From: Williams, Chris, EMNRD
Sent: Monday, July 09, 2007 7:02 AM
To: 'Randy Patterson'
Subject: RE: Good 13 State 1 Revised Proposed BOP (Forster Rig 15) - Lea Co., NM

From: Randy Patterson [mailto:RPatterson@chkenegy.com]
Sent: Friday, July 06, 2007 4:08 PM
To: Williams, Chris, EMNRD
Cc: Shay Stricklin
Subject: Good 13 State 1 Revised Proposed BOP (Forster Rig 15) - Lea Co., NM

BLOWOUT PREVENTOR SCHEMATIC

WELL : Good 13 State 1 30-025-38334

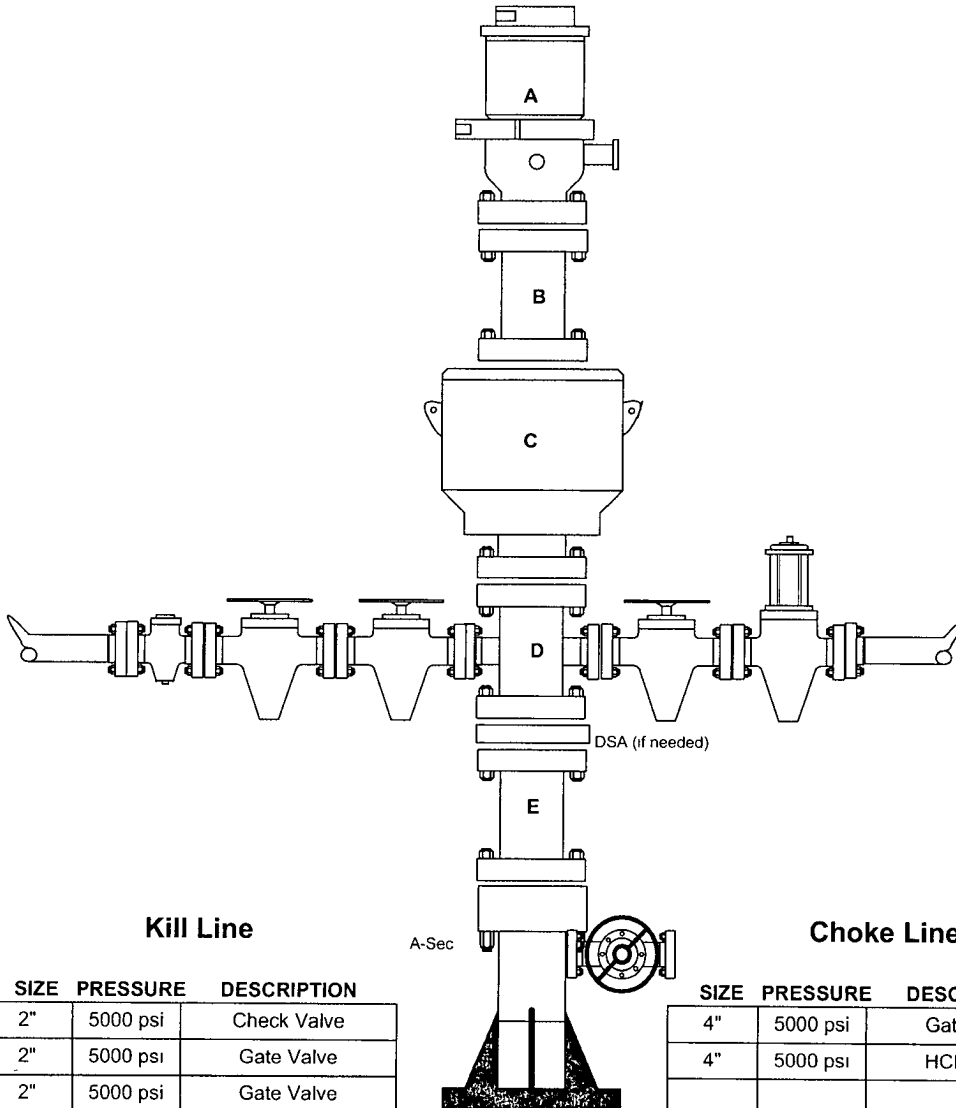
Chris,
Similar to the request below for the Lawrence 29-1 (with Latshaw Rig 6), we need to make a similar appeal for our Good 13 State 1 well since the Forster Rig 15 has 11" BOP stack and we will need to rent a 13-5/8" stack only for the intermediate hole section (drill out of 11" hole below the 13-3/8" casing). This single shut in stack should be sufficient should we need to shut in the well due to a shallow gas or air flow. We can then install the full rig BOP after we run and cement the 8-5/8" intermediate casing at 4100'. Please let me know if the NMOCD approves of this verbal request since this well will spud this weekend and do the first nipple up and test prior to Monday.

OK go ahead.
